STAFF RECOMMENDATION

NCPC File No. 5853

E. BARRETT PRETTYMAN U.S. COURTHOUSE
ANNEX PERIMETER SECURITY
333 Constitution Avenue, NW
Washington, D.C.

February 26, 2004

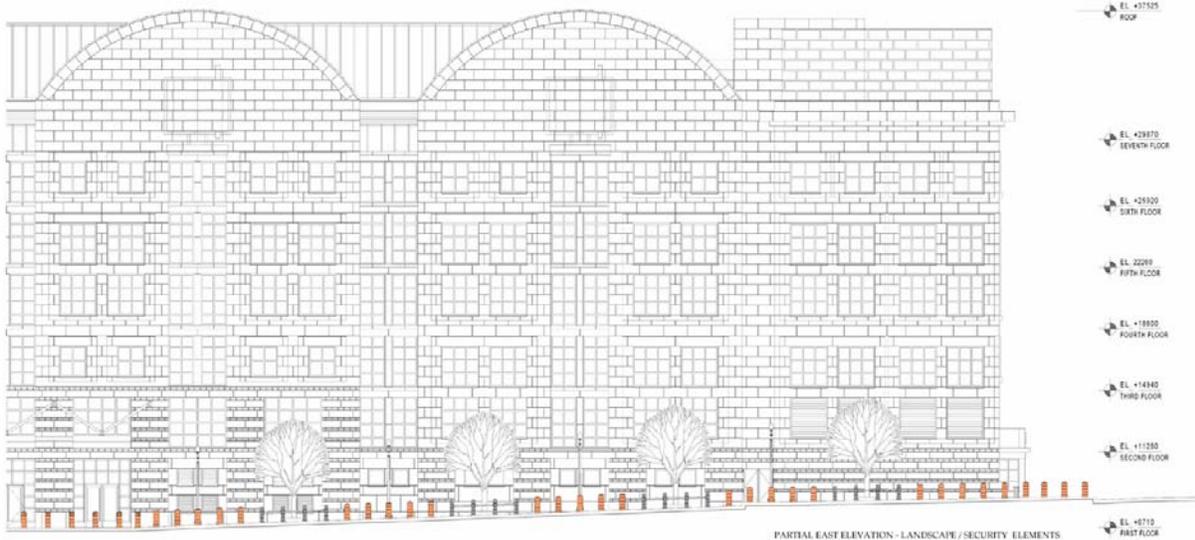
The applicant has designed a special post and rail element for use in front of the eight street trees that line the 3rd Street side of the building. The post and rail elements match the finish of the bollards in front of the 3rd Street building entrance as well as that of the Washington Globe street lights. The vertical posts are identical in size and shape to the entry bollards. The horizontal rail complements the vertical post design and serves to prohibit movement from the street to the sidewalk at this location. When viewed along the street from a distance, these elements appear as voids in the bollard line because of their dark color, helping to break up the appearance of the overall perimeter security design. The bollard line appears to be punctuated by the trees.

Corner Condition at 3rd Street, NW and C Street, NW

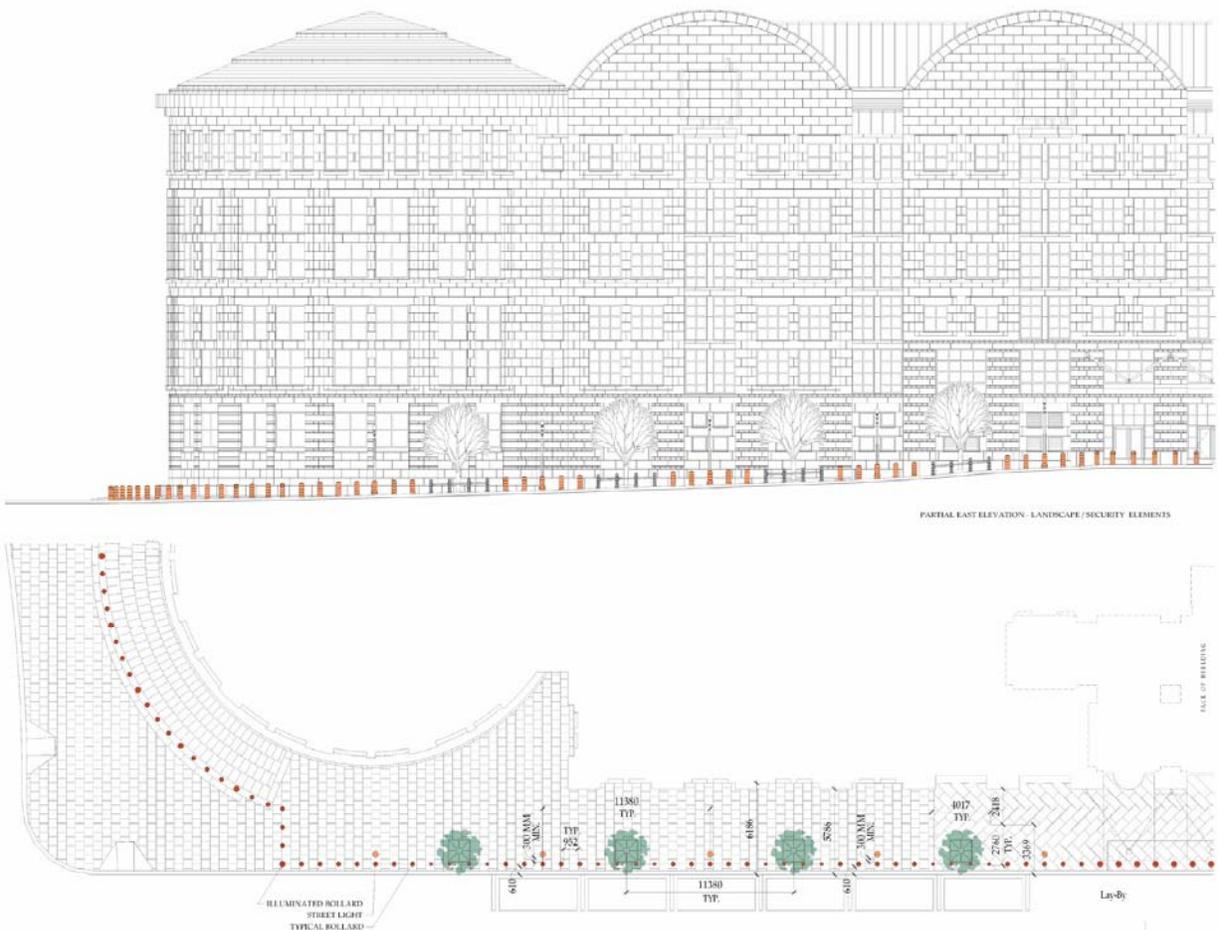
- Pull back the bollard line at the corner of C Street, NW and 3rd Street, NW to allow standing room for pedestrians waiting to cross the street at this location.
- Participate in early consultation meetings with NCPC staff prior to submitting perimeter security projects for the main Prettyman Courthouse building to ensure coordination between this project and future adjoining perimeter security measures.

The project includes perimeter security elements at two street corners. These are the northwest corner of 3rd Street, NW and Constitution Avenue, NW and the southwest corner of 3rd Street, NW and C Street, NW. The placement of bollards at these two locations is responsive to the specific conditions at each corner location. At the corner of 3rd Street and C Street, the bollard line is pulled back behind the wheelchair ramp at that location. The space created on the far side of the bollard line may not allow adequate room for pedestrians waiting to cross the intersection. The bollards should be pulled back at this location.
